Subject: Comments Regarding Agenda Item No. 9 - Material Change in Project Due To Subsidence Risks, Methylmercury Contamination Due To Dunnigan Pipeline and Change in Yolo Bypass Flows

Appendix I. Update on Land Subsidence in California

California's Groundwater: Bulletin 118 – Update 2025

Figure 3-95. T 200 Long-term Subsidence Plot; Colusa Subbasin.

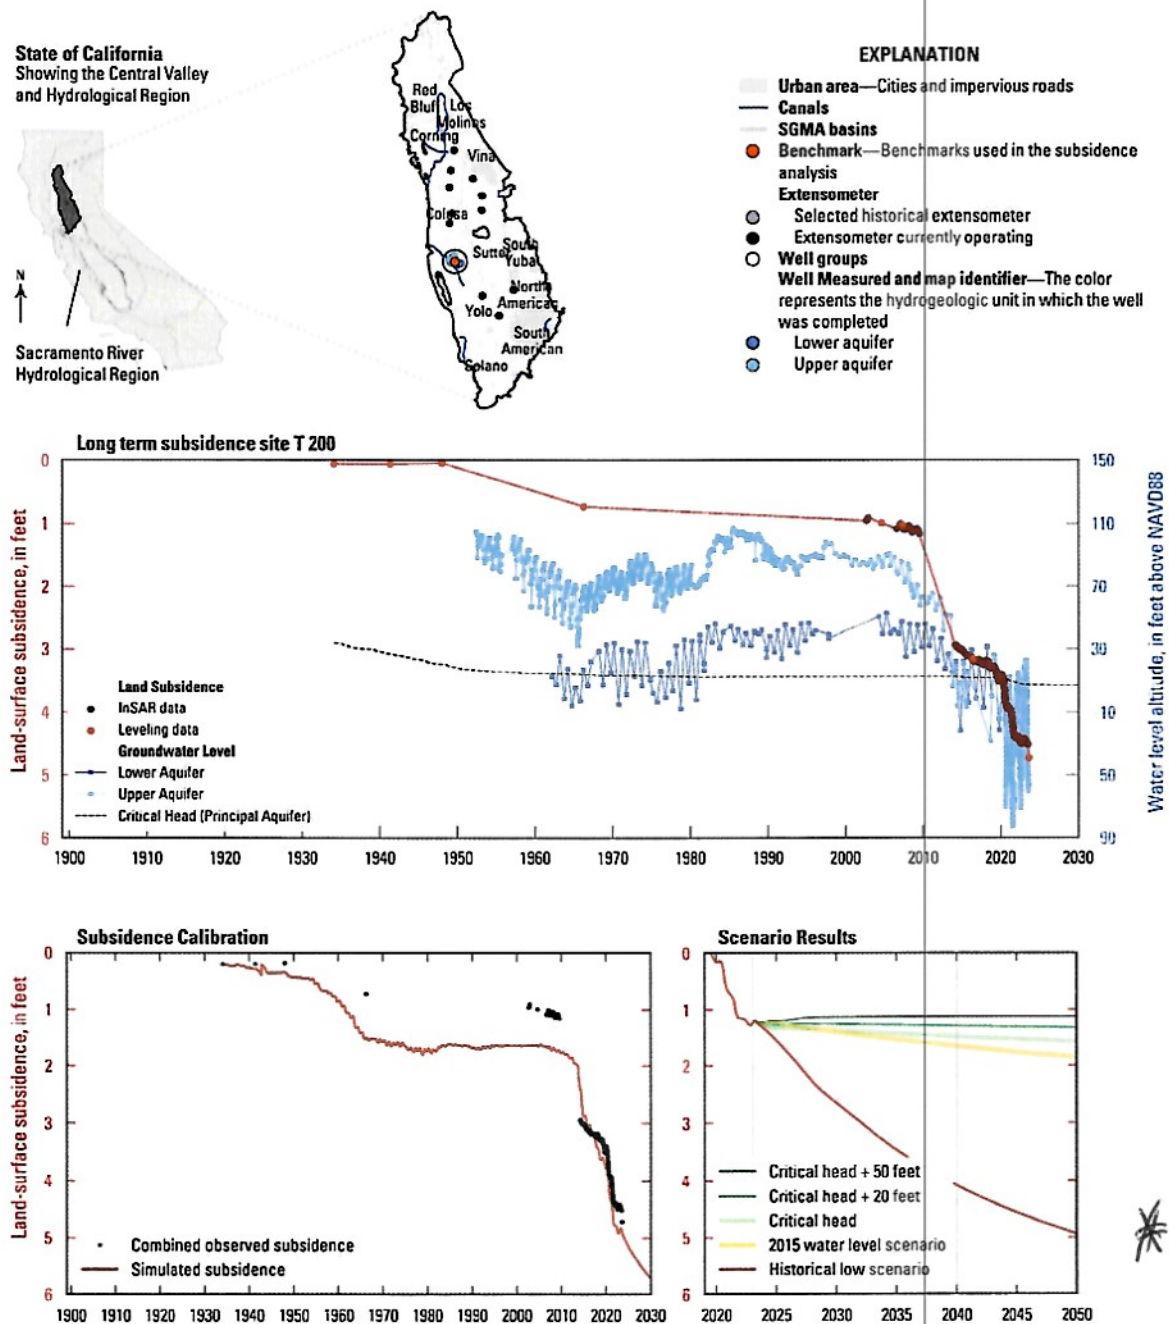
- **I have attached excerpts from Appendix I – Update on Subsidence in California for California Groundwater: Bulletin 118 – Update 2025 which shows subsidence on the Tehama Colusa Canal near Arbuckle has been trending at an average of 2 feet every 10 years. Have the costs of repairing the subsidence on the Tehama Colusa Canal and the potential for supply disruption down the Tehama Colusa Canal to the proposed Dunnigan Pipeline been considered? What is the real Resiliency of the Sites Reservoir if its only conveyance structure, the Tehama Colusa Canal, could experience 10 feet of subsidence in the next 50 years? What is the Public Benefit Ratio of a conveyance infrastructure without any planned redundancy?**

BETWEEN 2010
AND 2030
1.5 - 5.75 FEET

4.25 FEET IN 20 YEARS.
